1. Introduction

Applilet3 for RL78 is a software tool to generate device driver code for on-chip peripherals. It generates device driver codes using user settings through GUI. Initialize code and API functions are provided.

4. Changes

This chapter describes changes from Applilet3 for RL78 V1.05.01 to V1.06.00.

4.1.5 Control correction of a competition pin

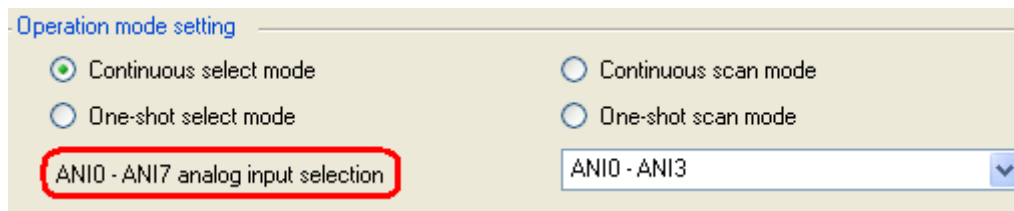
Control of the competition pin when simple-I2C of 24 and 25 pin device of RL78/G13 is set up was corrected.

Before : P17/SDA11

P30/SCL11

After : P50/SDA11

P30/SCL11

4.1.13 Changes of Simplified I2C

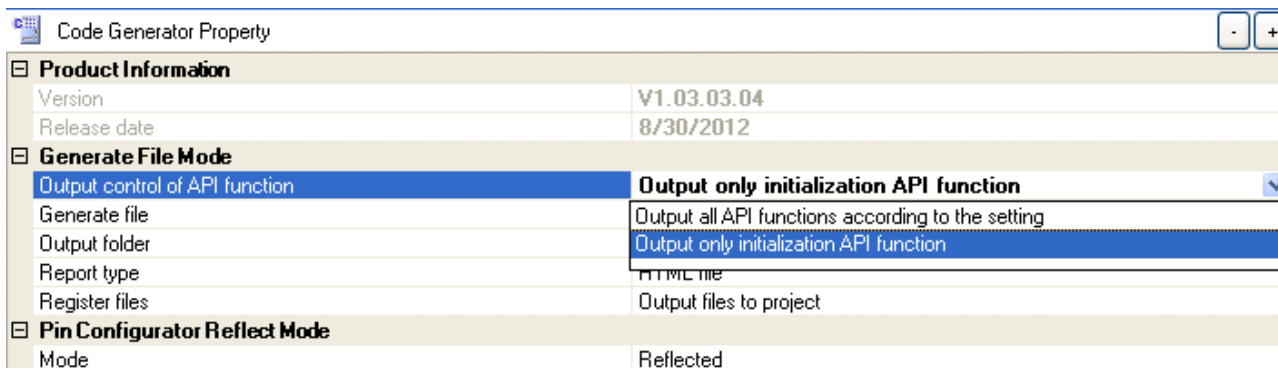
I When a receiving byte is set to 1 by Simplified I2C, it does not operate normally.

This issue has been corrected

4.1.18 Changes of input pulse interval measurement of TAU

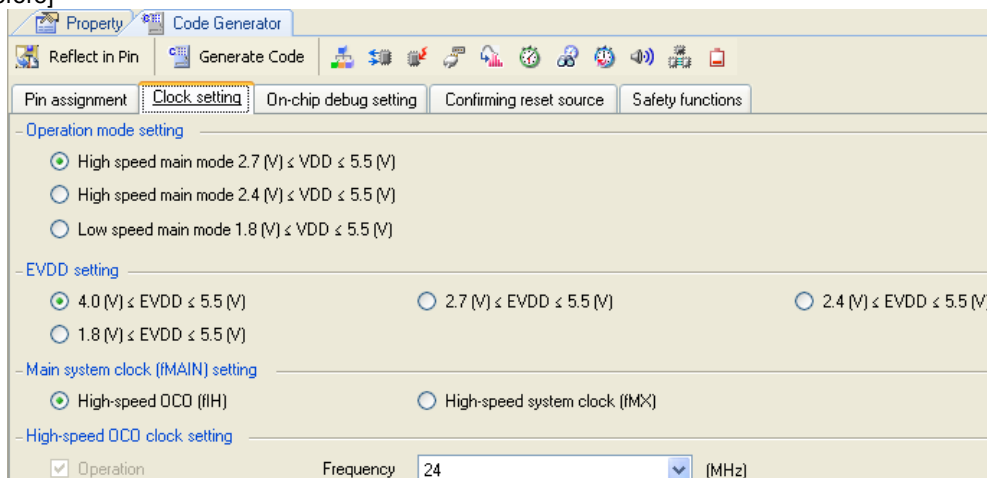
It corrected that the right measured value was not able to be acquired for the input pulse interval measurement function of TAU, and a high / low width measurement function by interruption function `r_taux_channelx_interrupt()` at the time of use.

This issue has been corrected

4.1.19 Changes the notation of a power supply

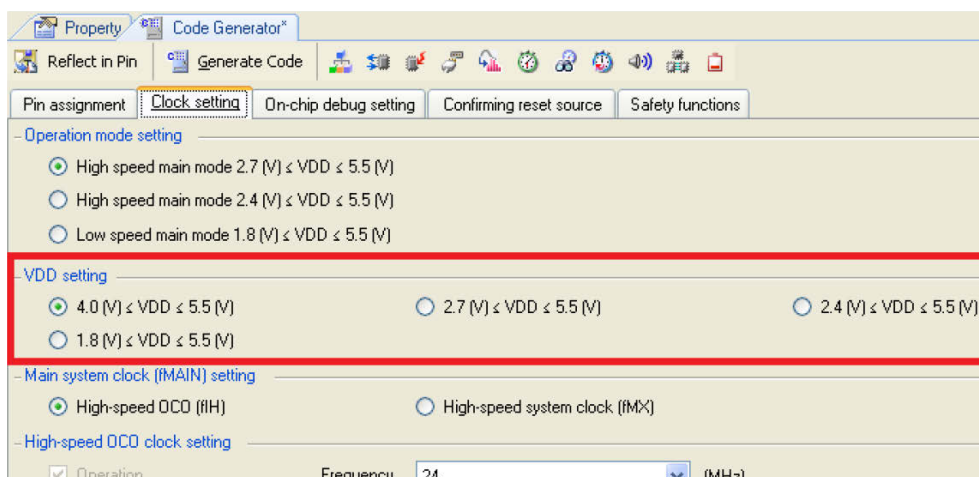
Although there was not EVDD in RL78/G12 device, it corrected that the notation remained on GUI.

This issue has been corrected in Applilet3 for RL78,78K0R,78K0 V2.00.00.
